Philips Electronics North America Corporation

November 4, 2010

RE: Docket No. 09-AAER-2

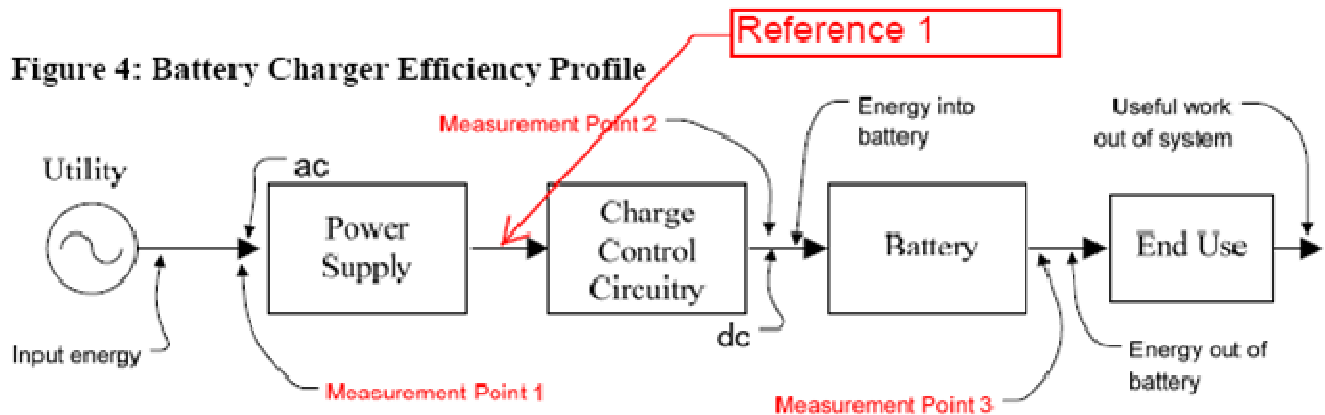
With respect to exit signs, if table 7 and figure 4 are supposed to represent energy use of exit signs they fail to take into account that the power supply feeds not only the charging circuitry but also the LED light bar as shown in the chart below.

All code standards require that exit signs are to be illuminated at all times. So a failure to consider this energy use is a significant flaw in the analysis
